Service Bulletin

Bulletin No.: 19-NA-040

Subject: Radio Screen Flickering when On

Brand:	Model:	Model Year:		VIN:		Engine:	Transmission:
		from	to	from	to		
Chevrolet	Volt	2019	2019			All	All

5246376

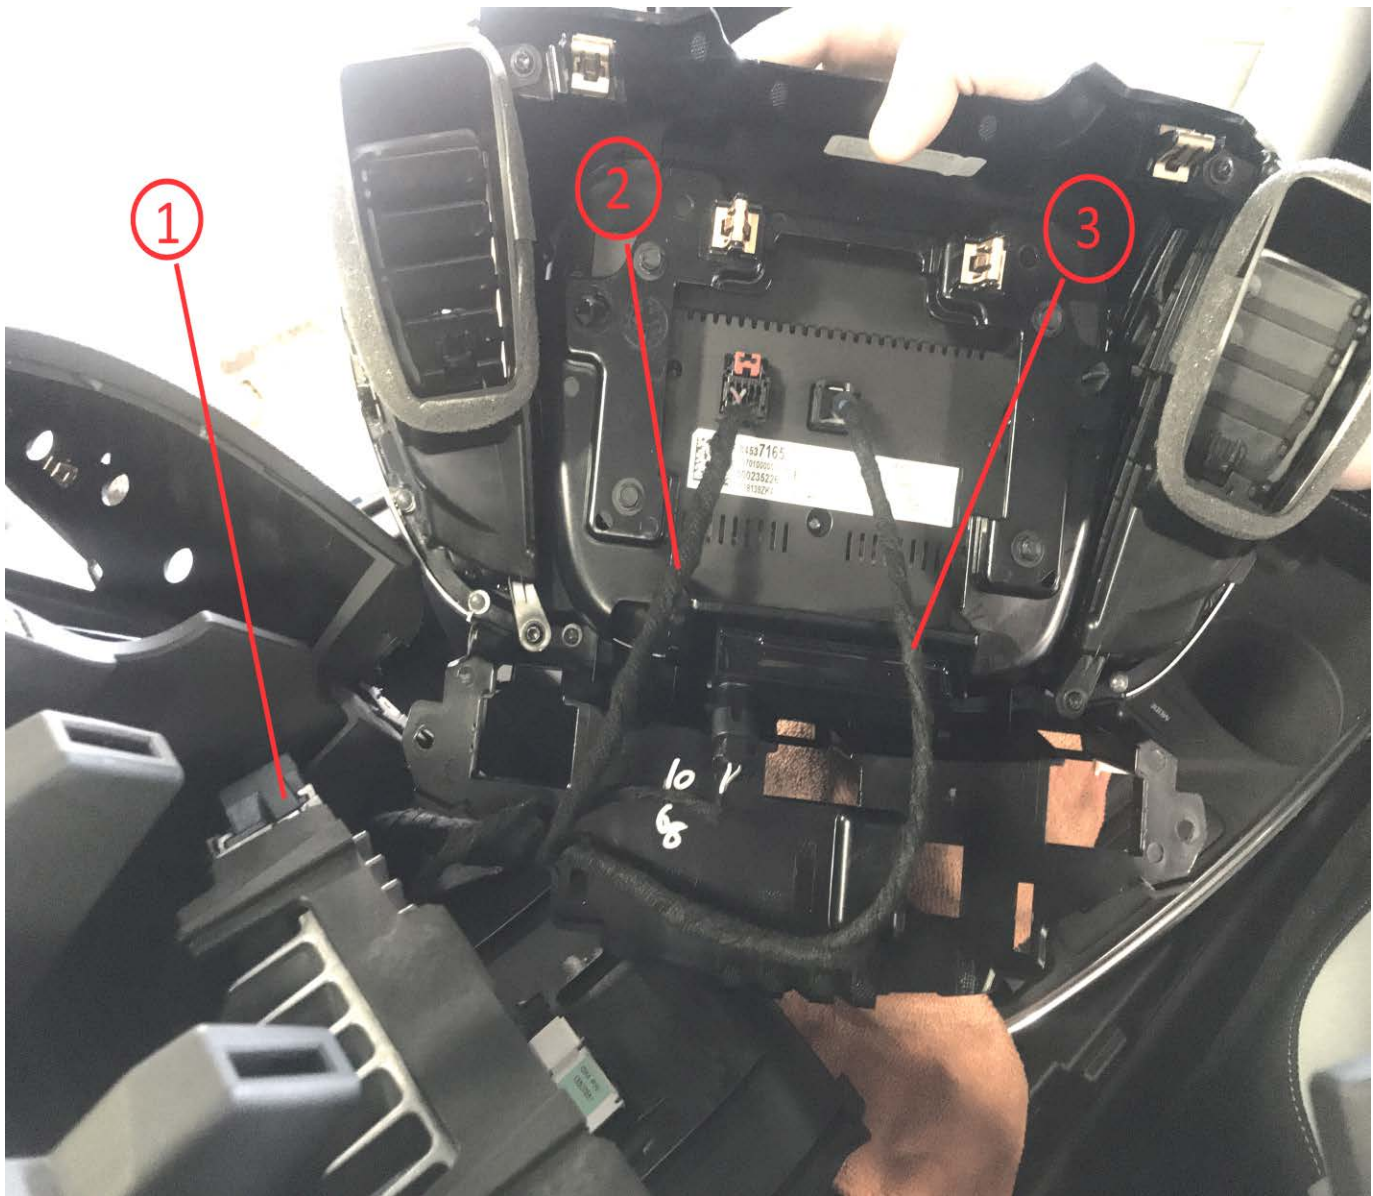
An example of possible screen flickering. If screen flickering is experienced, then the wiring harness behind the radio needs to be rerouted and held with zip ties.

Example of back of the radio before rerouting the wires

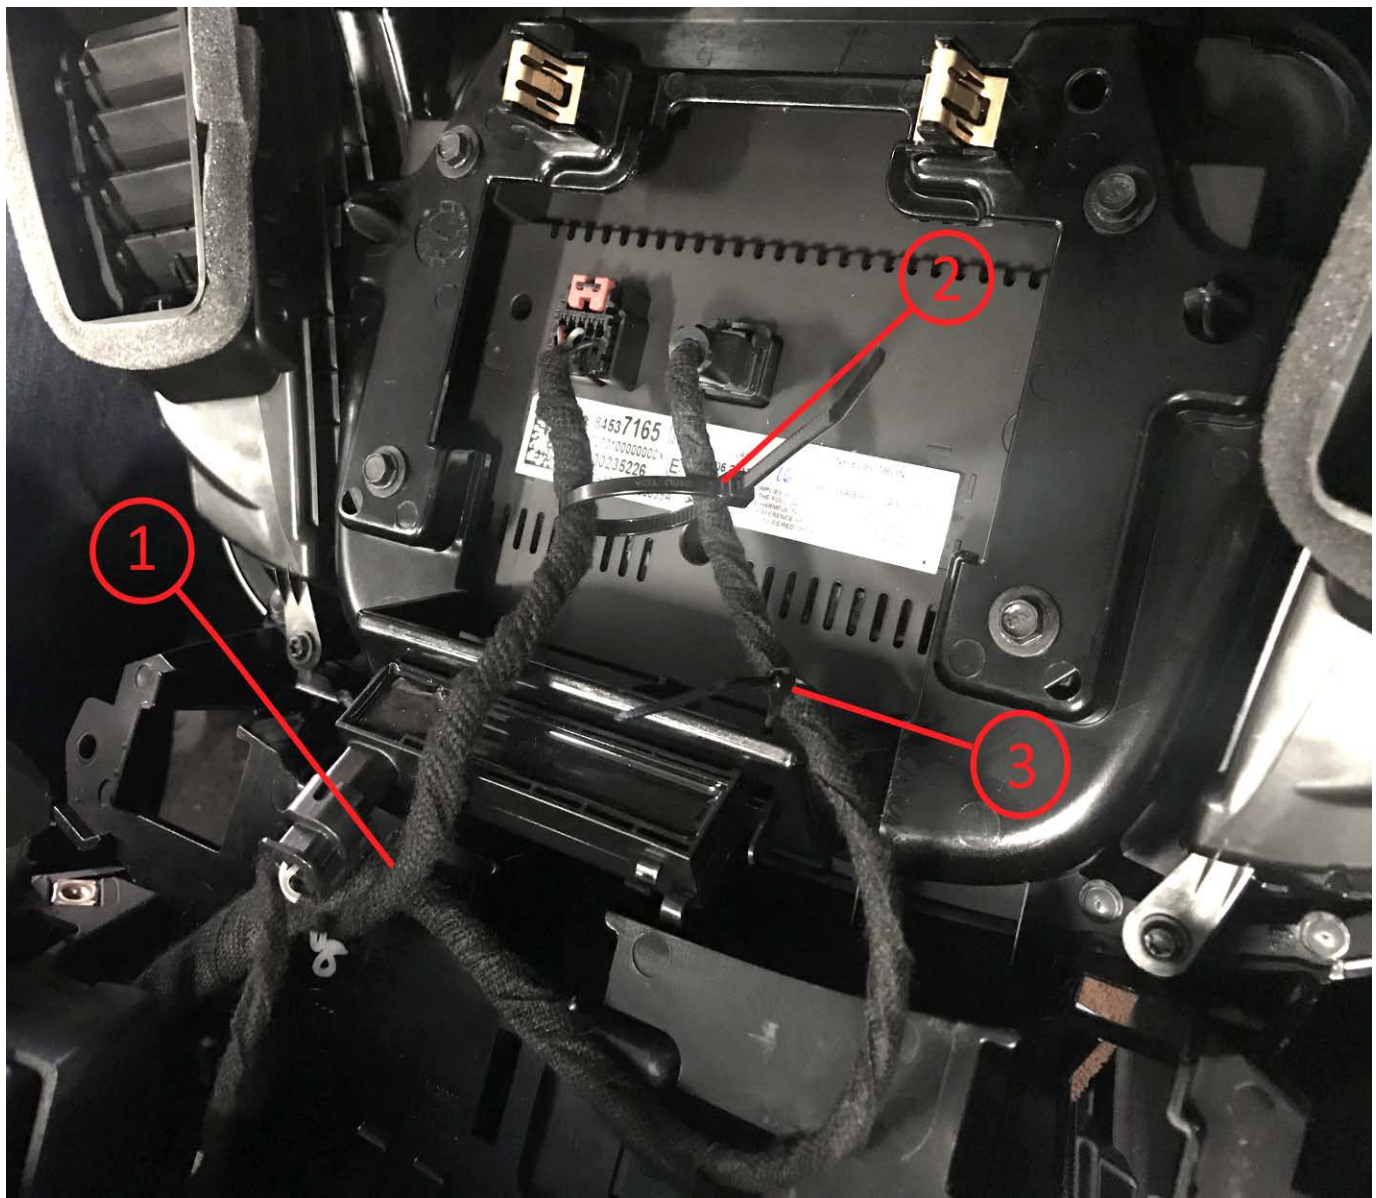
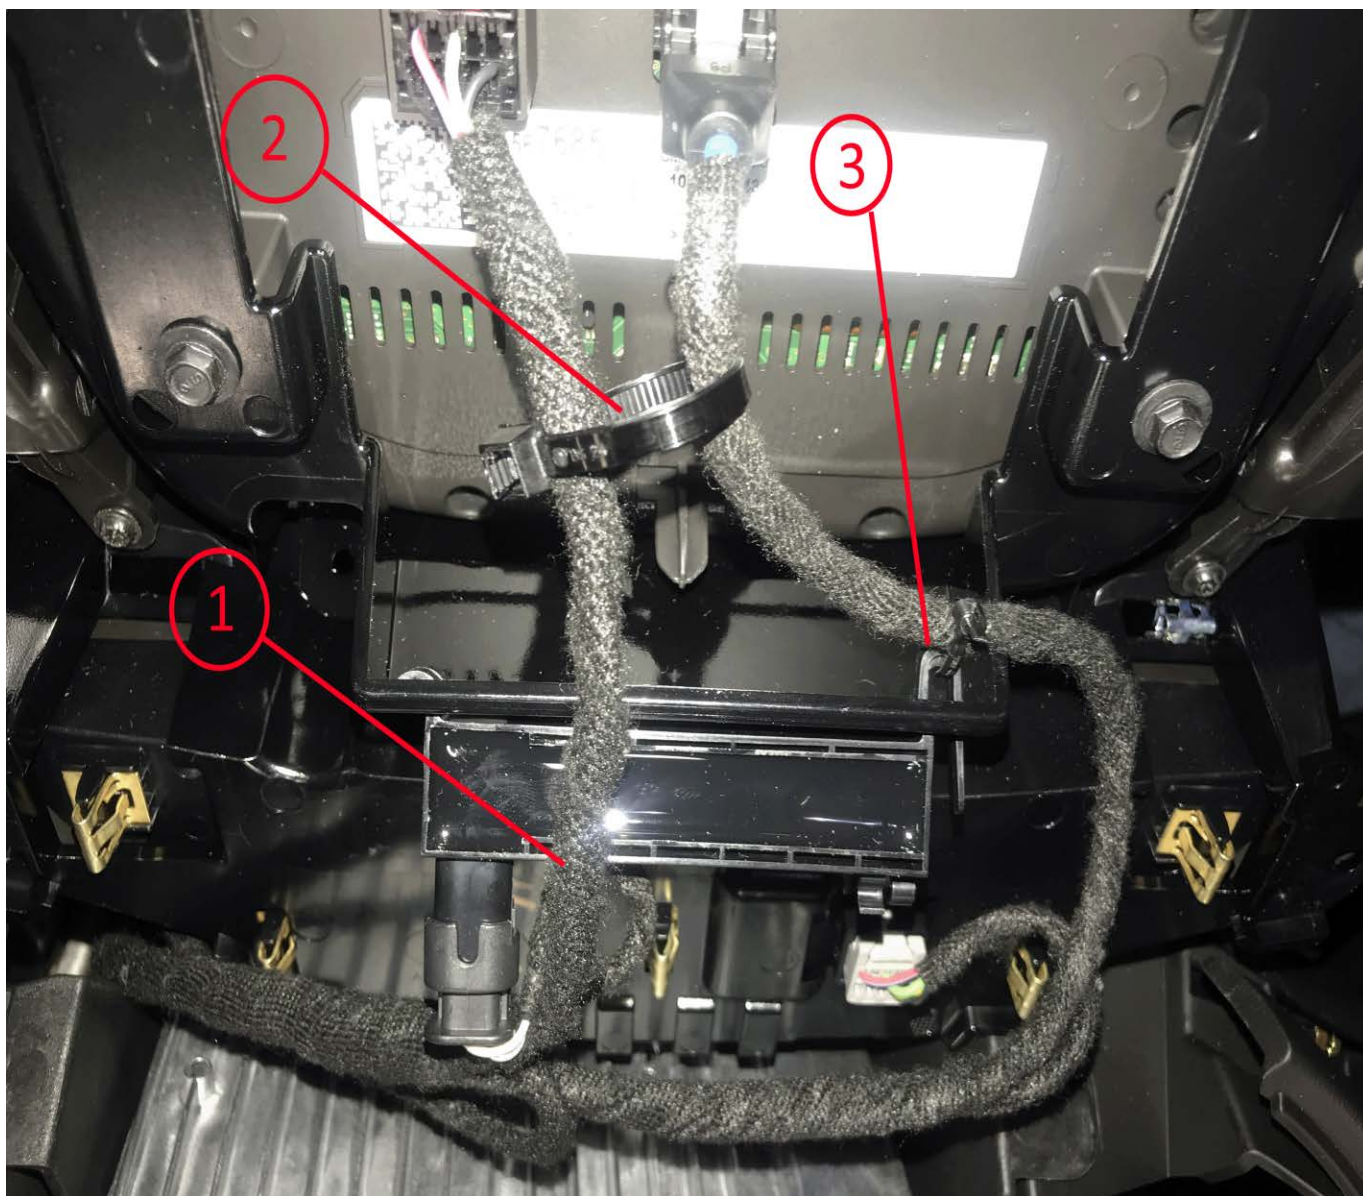
Once there is access to the back of the radio, look behind to reroute wires to prevent covering WiFi Antenna.

1. WiFi Antenna
2. Branch Integrated Center Stack (ICS)-Power cable
3. Branch Low Voltage Differential Signaling (LVDS) cable
